CONVAIR

COMMERCIAL CHANGE PROPOSAL

SPEC NO.: ZD- 22-324

MODEL: 22-21(#3) (Convair "880")

GENERAL ARRANGEMENT

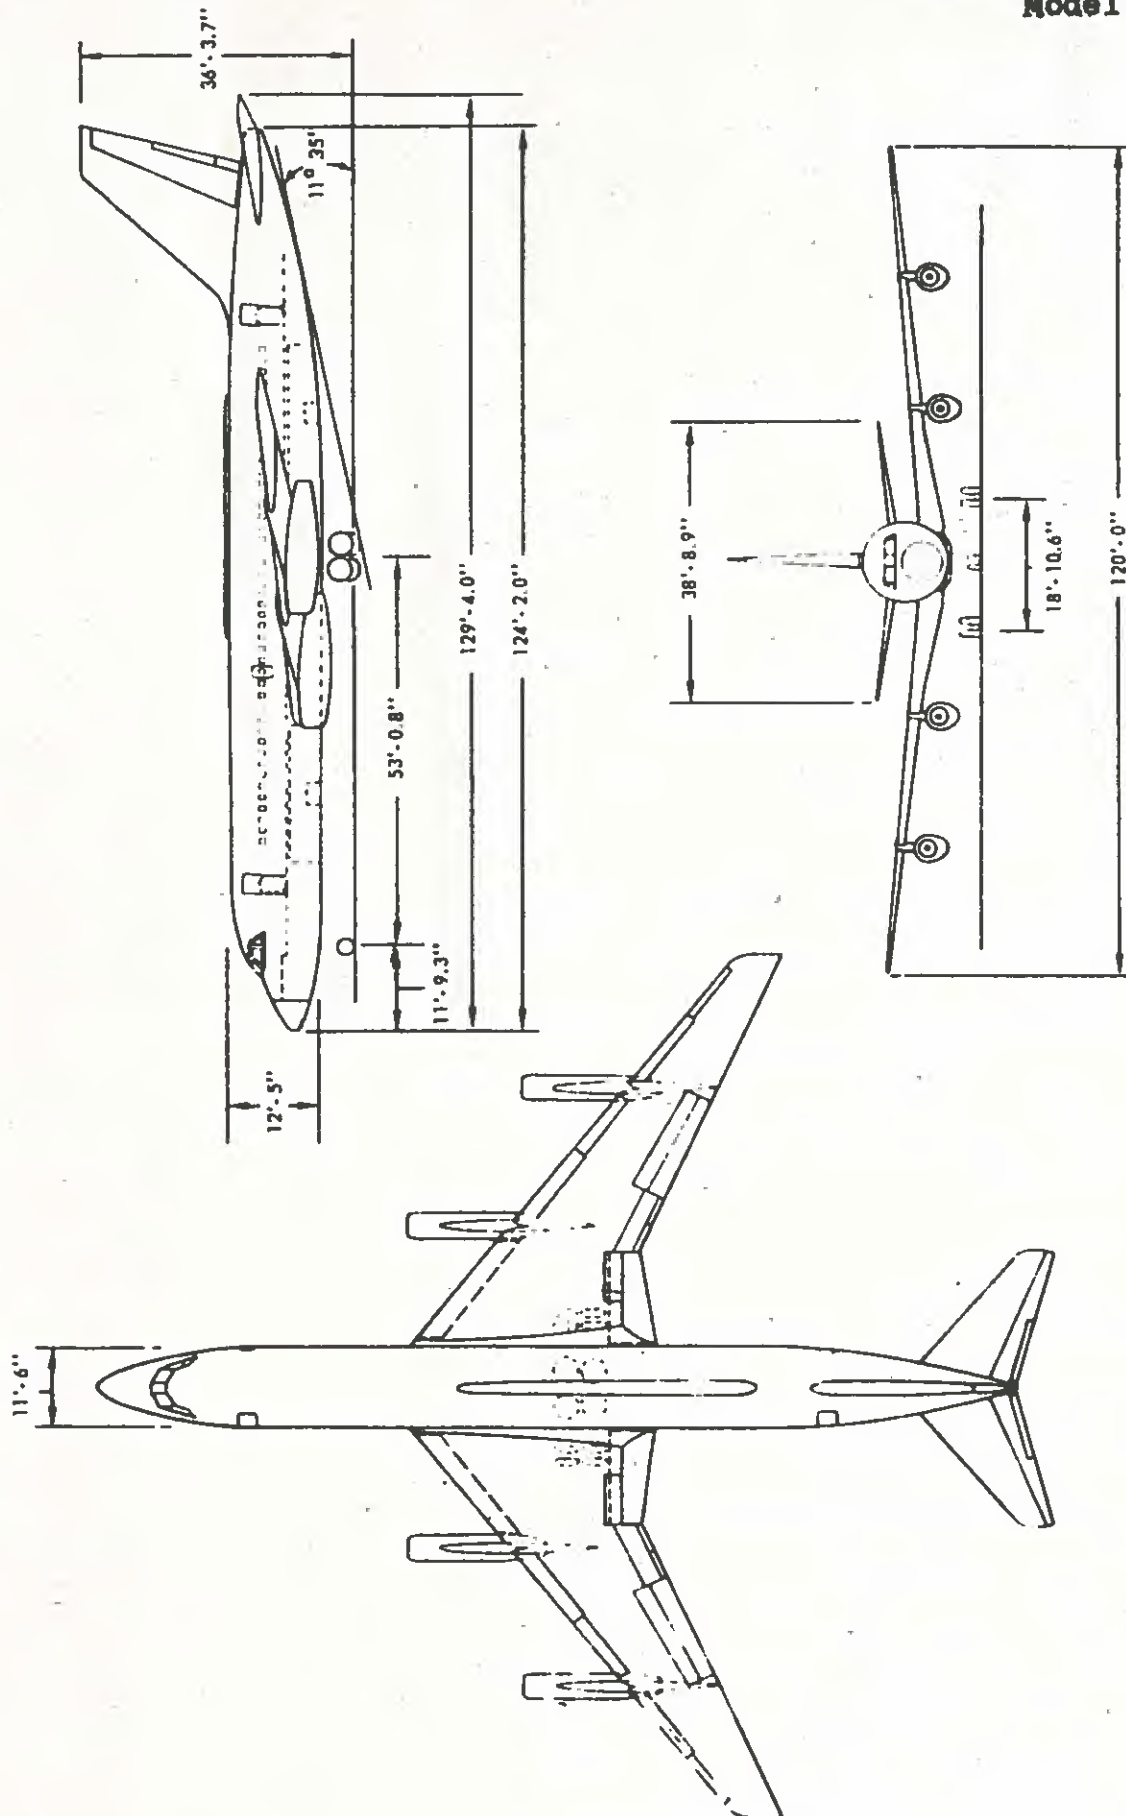
Page 3a, GENERAL ARRANGEMENT:

Replace above illustration in the specification with Enclosure (A) which shows Krueger Flap installation between inboard pylon and fuselage, and trailing edge inboard flap extension.

Enclosure: (A) One copy Page 3a - GENERAL ARRANGEMENT (Revised)

INTERIOR ARRANGEMENT
40 FIRST CLASS PASSENGERS
FAA

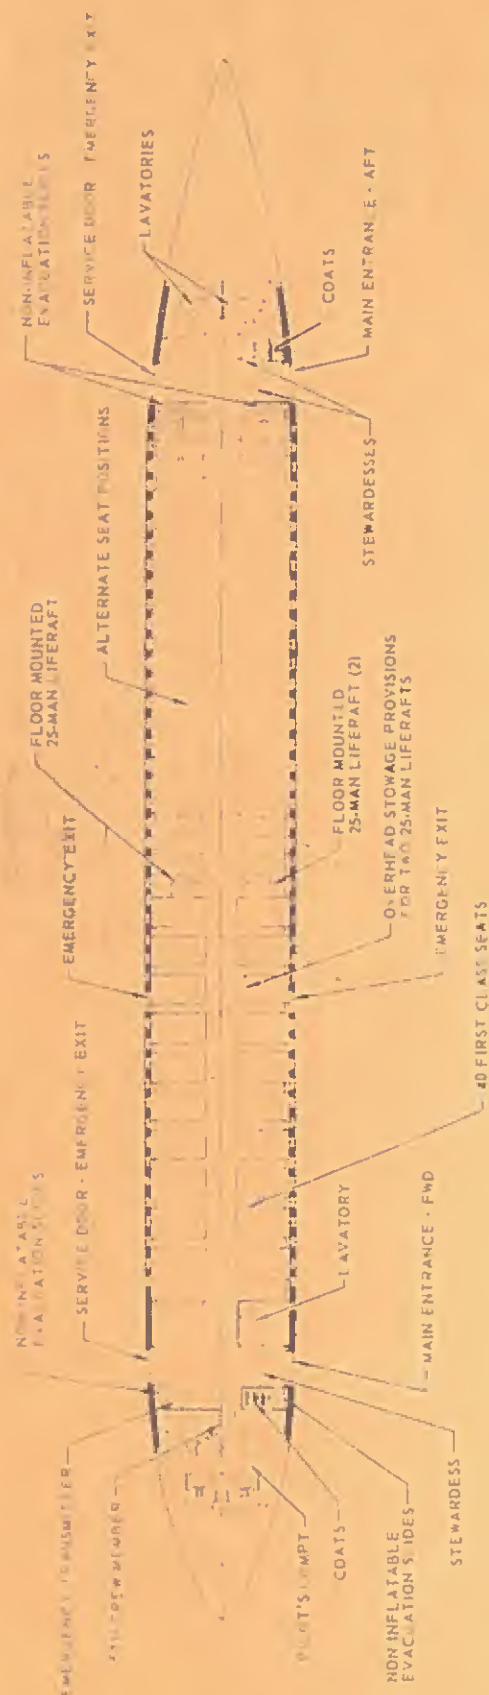
Page 3b, INTERIOR ARRANGEMENT:

Replace the above illustration with Enclosure (A) which shows the effects of this proposal.

Enclosure: (A) One copy Page 3b - INTERIOR ARRANGEMENT (Revised)
